ONE SYDNEY HARBOUR

BARANGAROO

R4B SUPPLEMENTARY DESIGN STATEMENT TO SUPPORT S4.55 MODIFICATION
June 2020

View 1 - Approved NE Elevation - Upper Plate

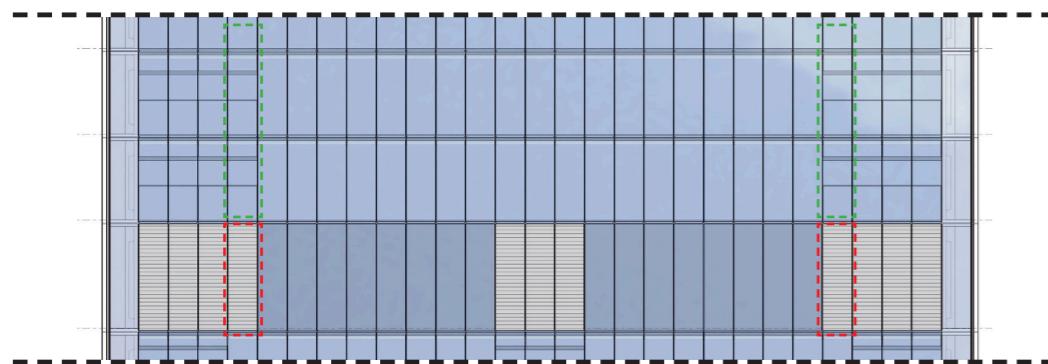
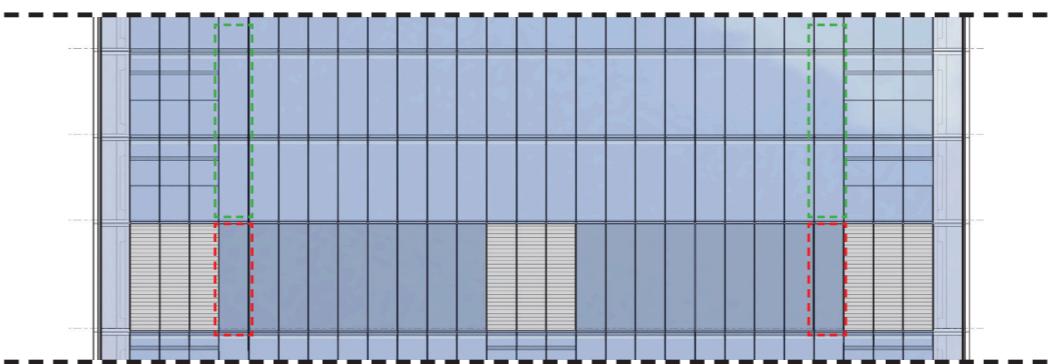
North East: Reduction in two wintergarden units, one at each end. This causes the wintergarden to line up with the units below in the low and mid-rise plates. Louvres trimmed back to follow.

View 2 - Approved W Elevation - Upper Plate

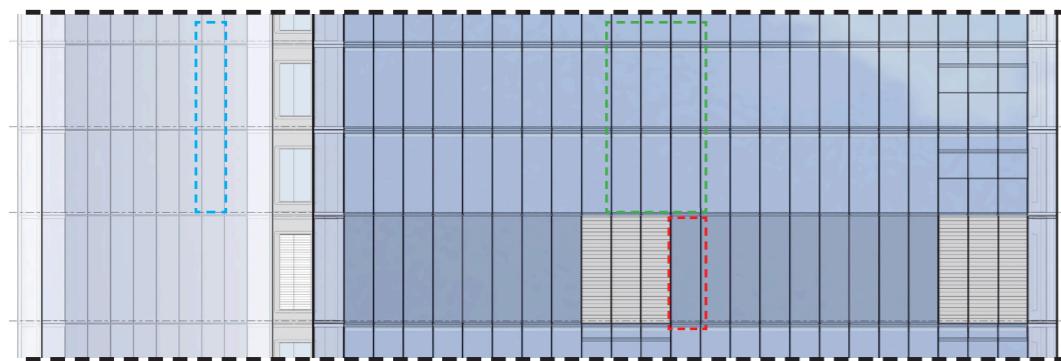
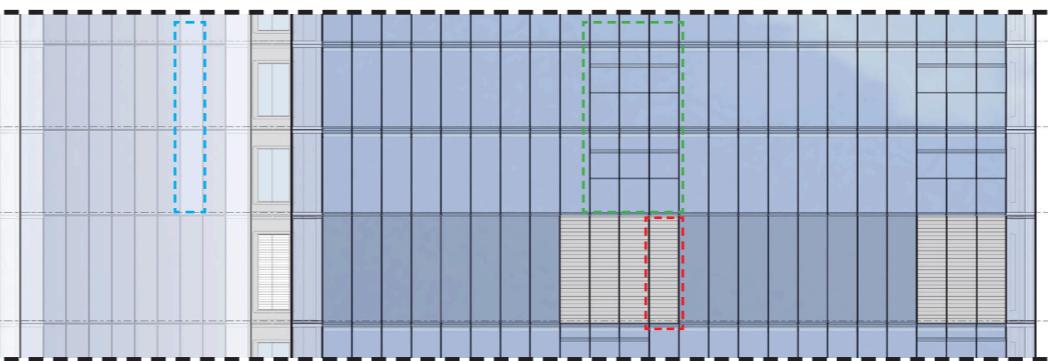
West: Extension of the second line of wintergardens up until the skyhomes. Added louvre at plantroom level creates a transition zone between the different alignments. Single Mini-OCF added to ventilate bedroom

View 3 - Approved SE Elevation - Upper Plate

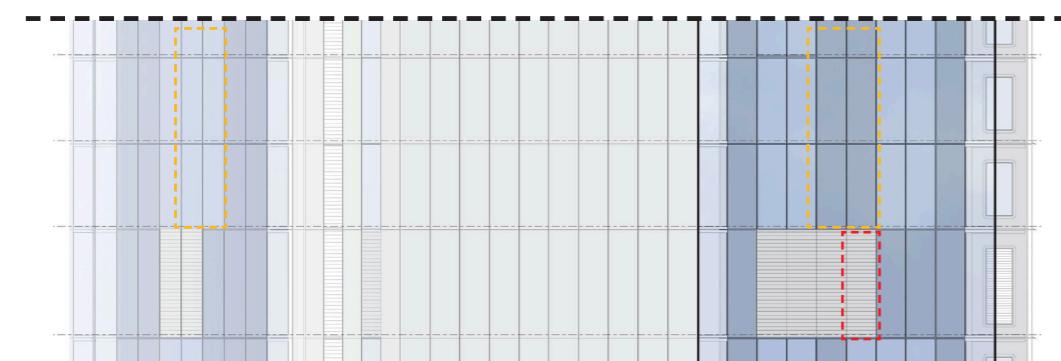
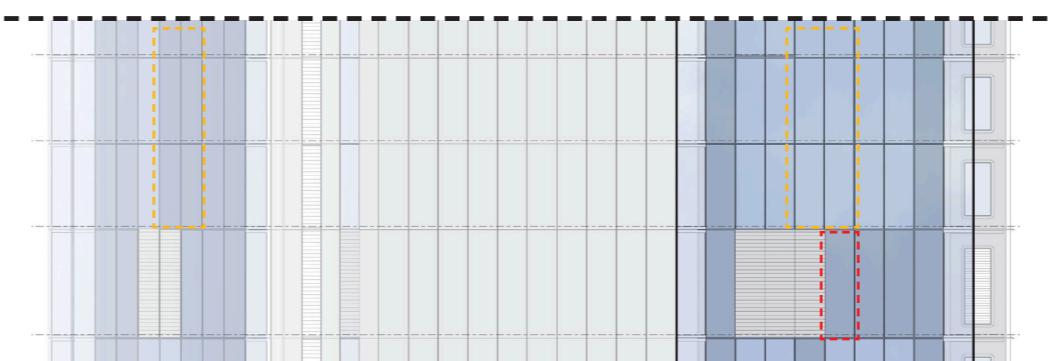
South: Simplification of the spandrel layout, extending only the edge ones. Trim on the plantroom louvres given mechanical recalculation of required ventilation.

Approved lower skyhomes layout plan - Level 56

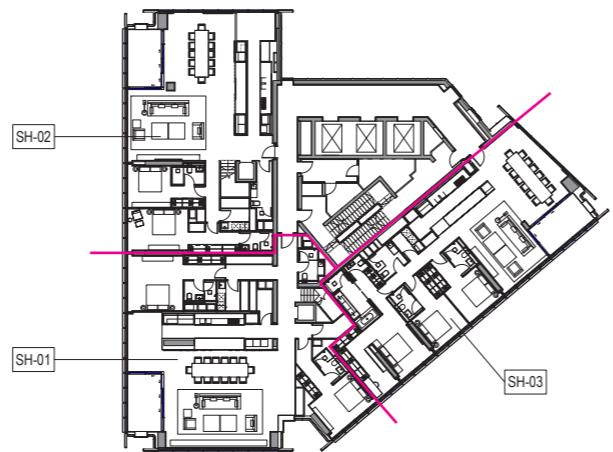
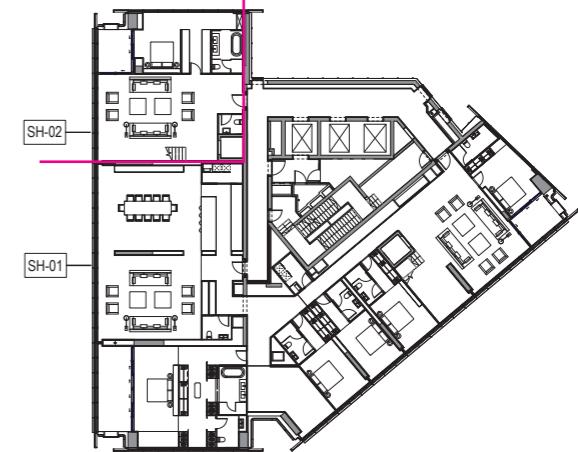
In the approved scheme, we have a single apartment opening to a substantial, but disproportionately large terrace and two others that lacked that amenity. The current proposal includes a review of the dimension of the west facing terrace, and the creation of a new opening of similar dimensions in the southern end of the north-east façade.

Approved Roof Layout

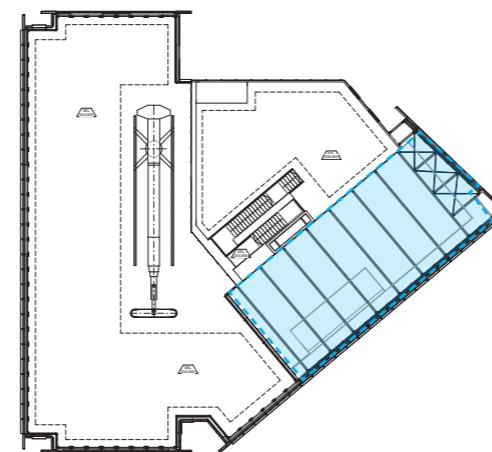
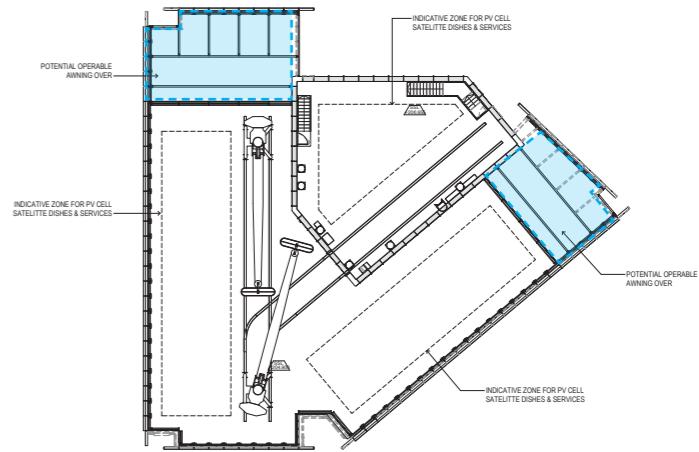
The top portion of the tower has also been reviewed in line with a change in the brief to offer two similar apartments instead of the three different ones in the current approval. The following layouts are now proposed. They create more balanced apartments not only in GFA and number of bedrooms, but also in access to amenities.

View 1 - Approved NE Elevation - Tower Top

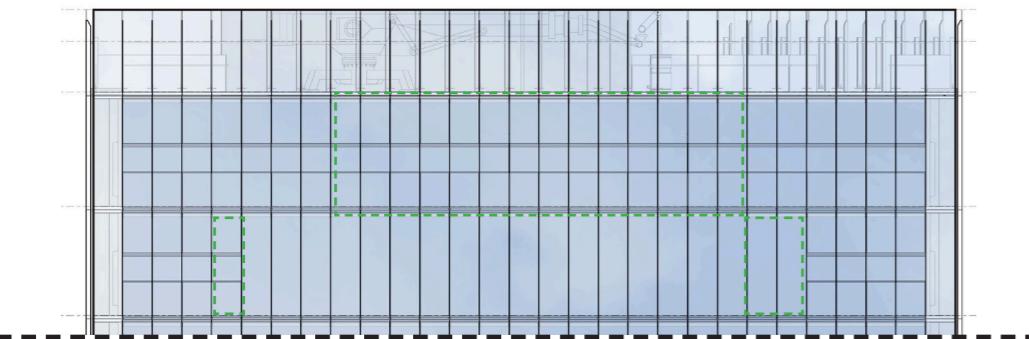
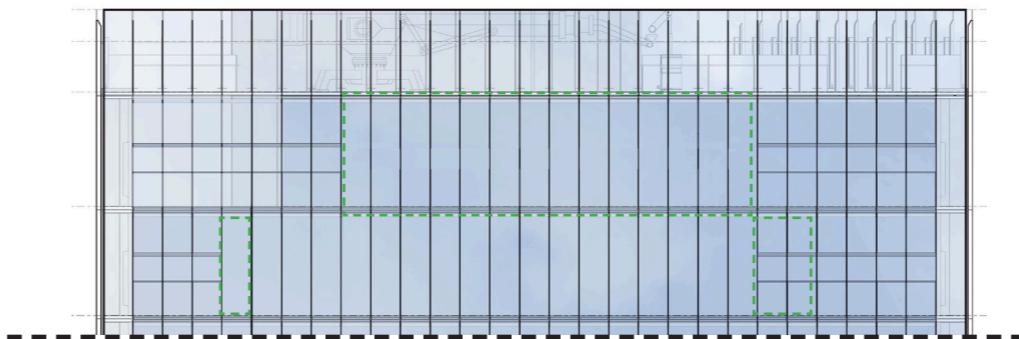
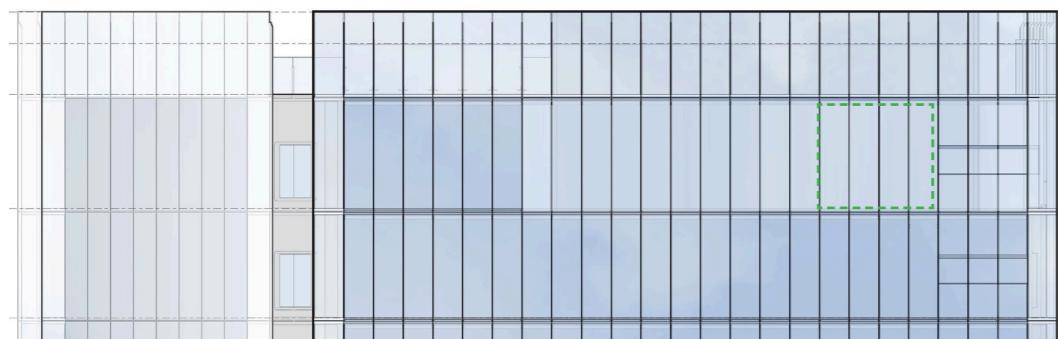
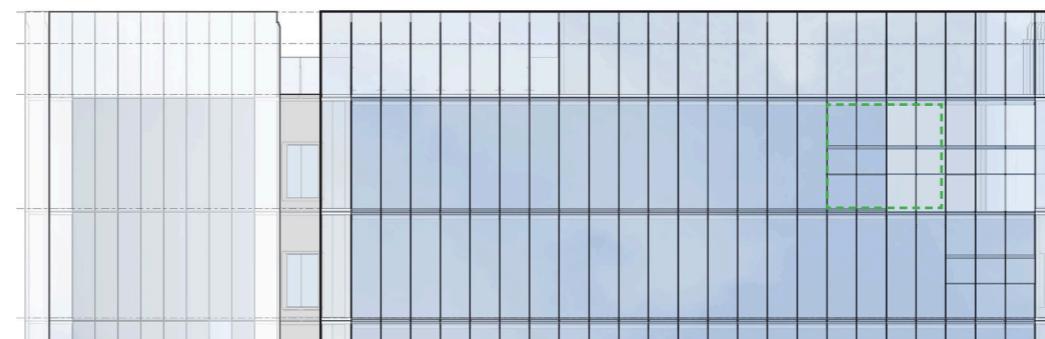
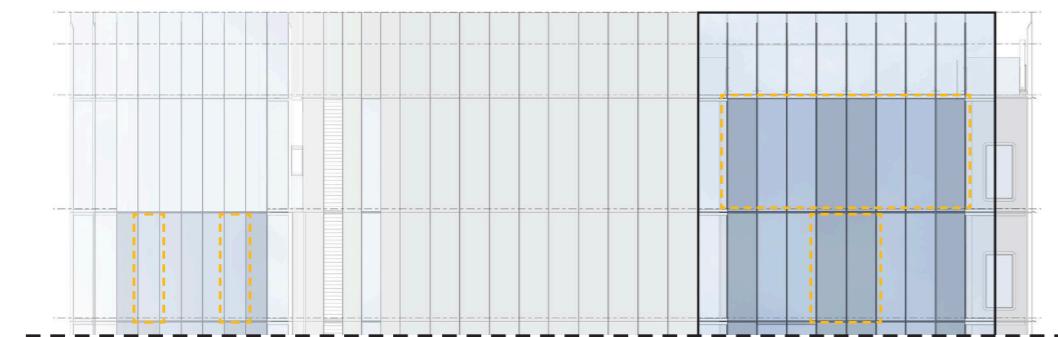
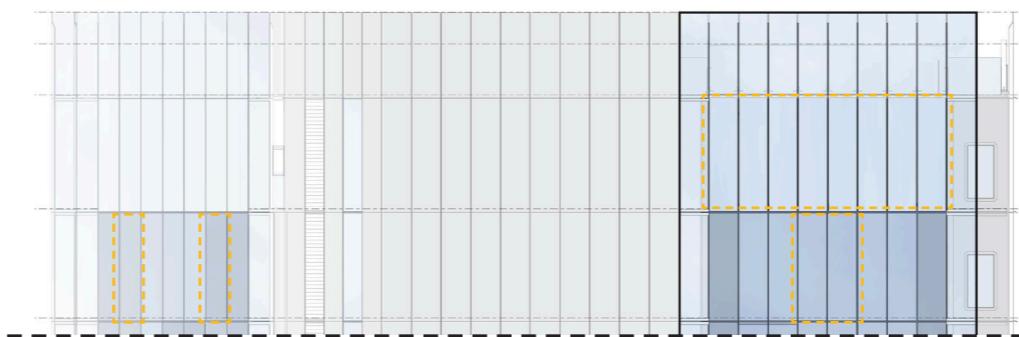
These changes also result in amendments to the facade. In addition to the NE and W facades with the new allocation of terraces, changes have been made to the wintergarden and spandrel extensions along all facades.

A key visual improvement comes when looking up to the building from the “piazza”, when viewed from Watermans Quay, SE from R4B. With the new terrace, at that point the pedestrians will be able to perceive very tall and clear glass facades crowning the top of both the S and SE building volumes. This consistency is likely to have a subtle but noteworthy positive impact on the building perception (this can be seen at the view 3).

Ref.1: Approved Skirt Bottom

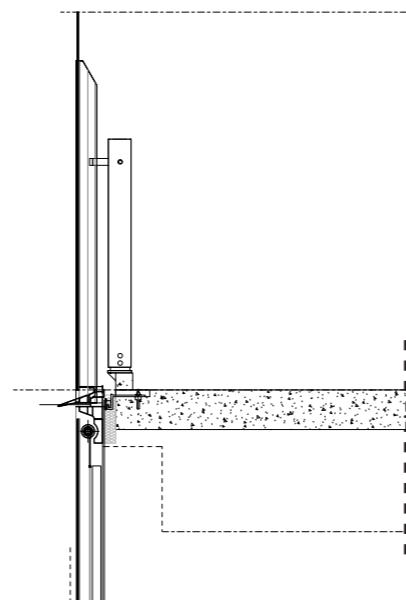
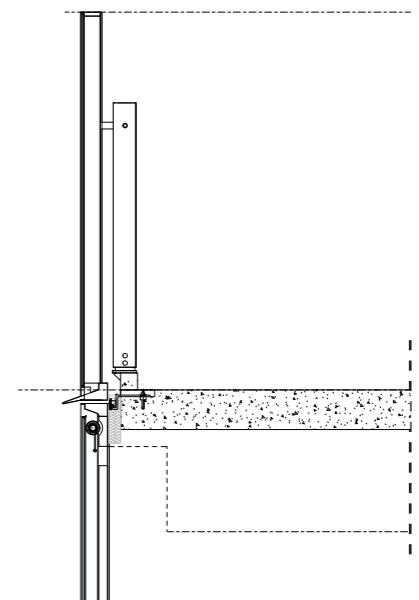
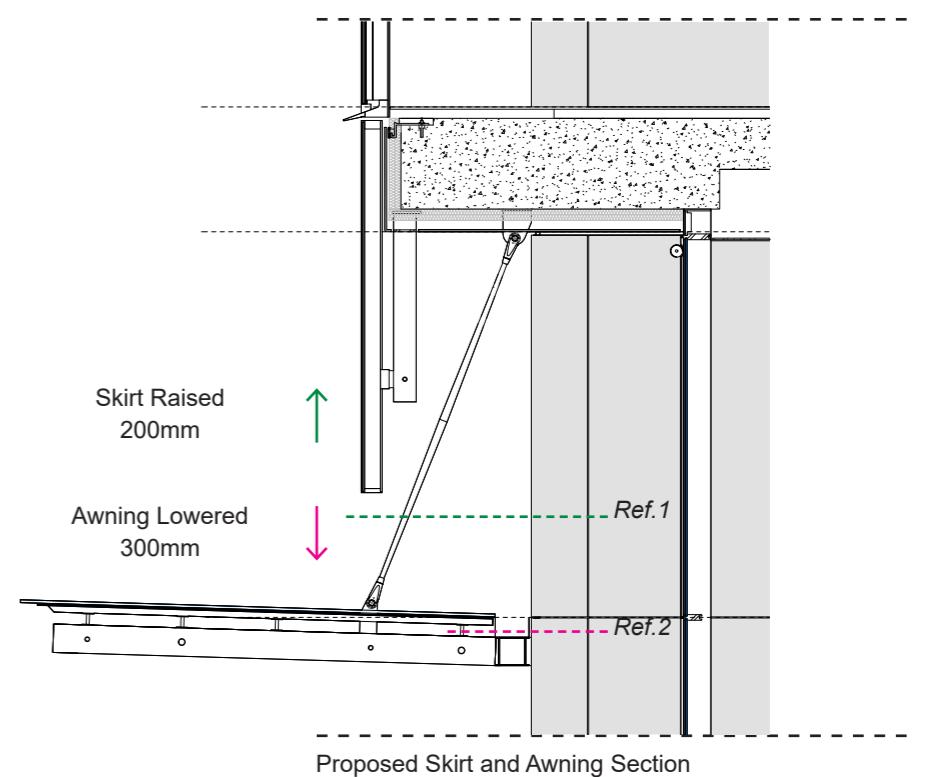
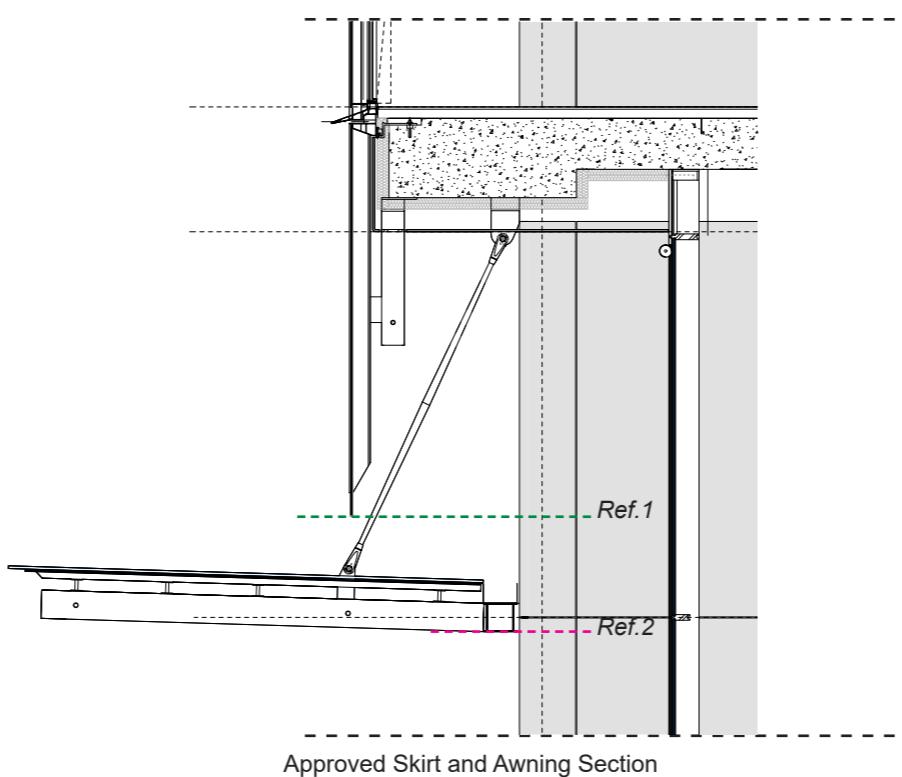
A minor amendment is proposed for the lowermost and uppermost façade panels (respectively, skirts and fringes). In the approved scheme, the edge of these panels are presented as exposed glass. During the development of the design a cap was proposed for both panels in response to the following intents:

-Second, to better respond to structural and durability concerns, in this way, safeguarding the design from potential damages and mainly, delamination problems.

The introduction of a bottom transom triggered a restudy of the awning and skirt relationship. To avoid a clash between this new element with the diagonal strut of the canopy, the skirt is proposed to be raised by 200mm and the awning, lowered by circa 300mm.

The shift in the awning is proposed in such way to align the top of its rear structure and gutter with the horizontal joint in the column cladding. Therefore, in the proposed scheme, only the lower cladding has any interference and cutouts for the awning anchorage, leaving the upper cladding clear of trims and perforations. This amendment is proposed for both the park awning and the entry vestibule one.

Approved P2 Plan

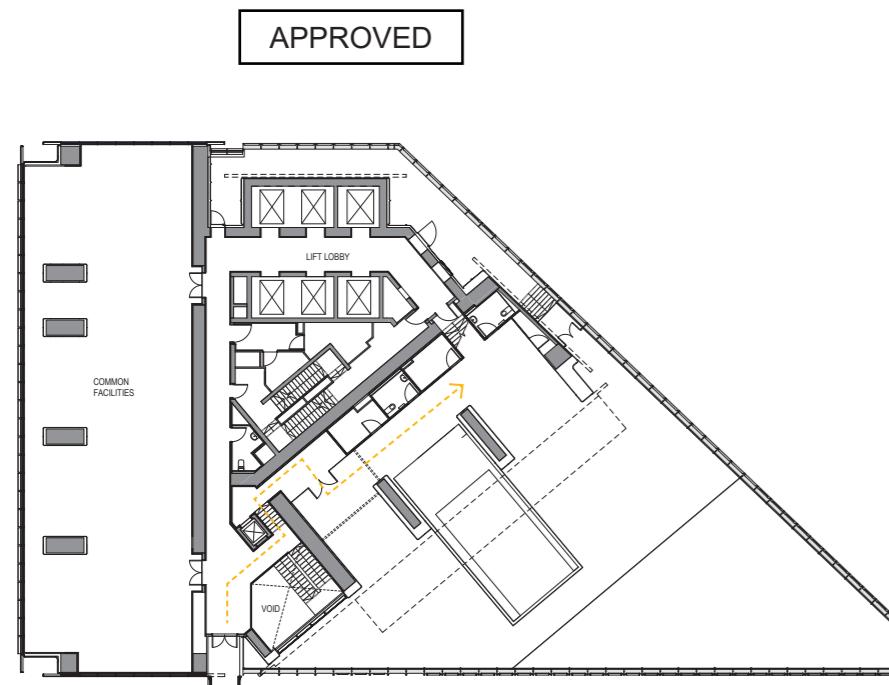
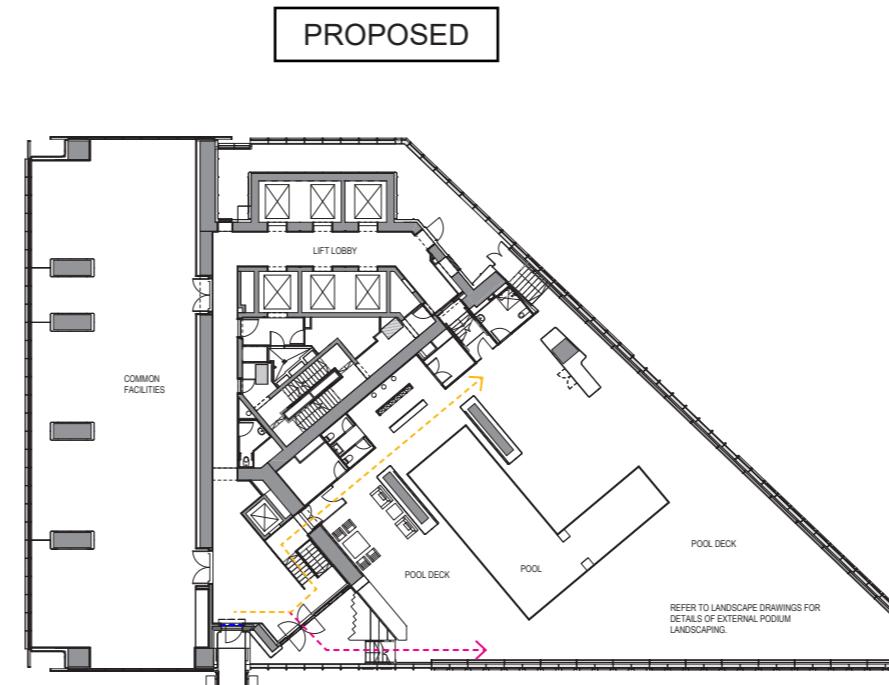
In the approved scheme, an Open Cavity Façade ('OCF') is present at this location. Unique structural arrangements makes it challenging to operate, maintain and prevent damage to the blinds, required for thermal performance at this orientation. Therefore, a fixed facade must be introduced. In light of this, the OCFs are proposed to be changed to fixed Double Glazed Units ('DGU') with the blinds directly behind the glass and readily accessible from inside.

The second amendment, being the introduction of a transom on the facade panels, is required due to technical constraints in the glass manufacturing process. Due to the height of glazing at this level, a minimal transom, splitting the glazing in two, was necessary. The new element is aligned to the adjoining 'skirts panels' (the lowermost panels of the tower façade) present above the podium, creating a consistent datum across the tower.

Approved P1 Plan

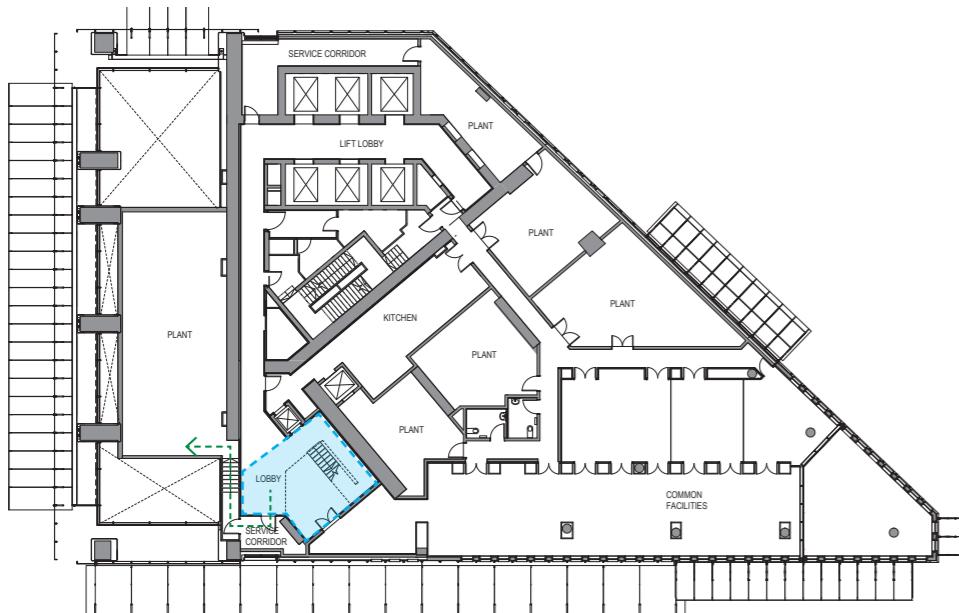
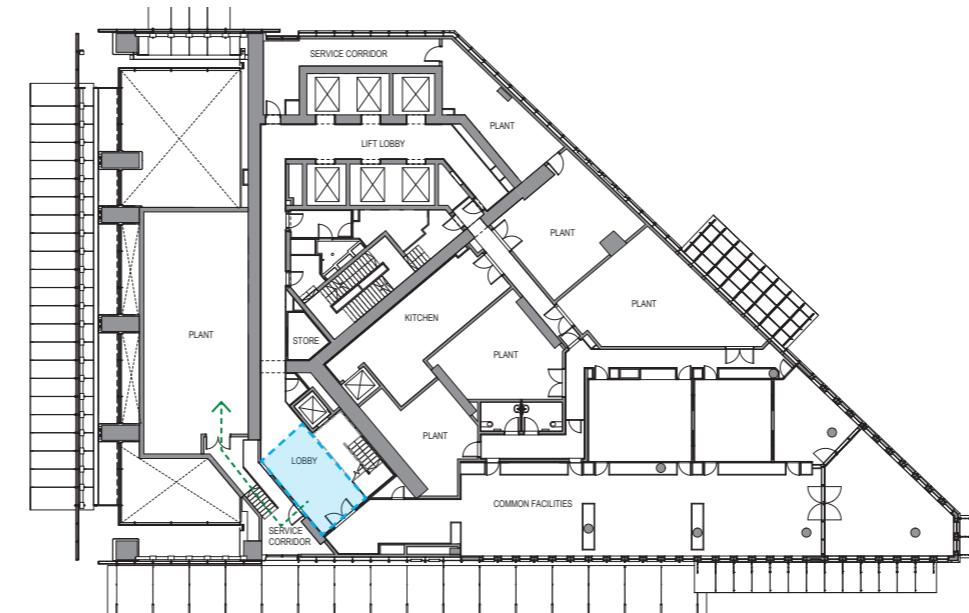
Internally, the amenities levels (P1 and P2) have also been reworked. After some structural revisions, it was deemed feasible to change the openings on the sheer wall leading to the exterior pool area. This cascaded in a series of small tweaks and refinements that would result in the rationalization of the overall circulation to that area.

Access to the P2 Exterior Amenities: The stairs in this area were simplified into a single staircase void seamlessly using a landing as connection point between P1/P2 and P2/Exterior amenities.

In addition to that, a new entrance was introduced that leads the user directly outside on the lower level, with stairs to reach the upper portion located near the podium GRC facade. This amendment enriches the area landscape and makes use of a previously residual space.

Access to P1 Amenities Lounge: With this proposed staircase, we reviewed the opening to the level above and simplified the shape of the space leading up to the lounge. Finally, we propose a more orthogonal area, greatly reducing the number of corners and residual spaces
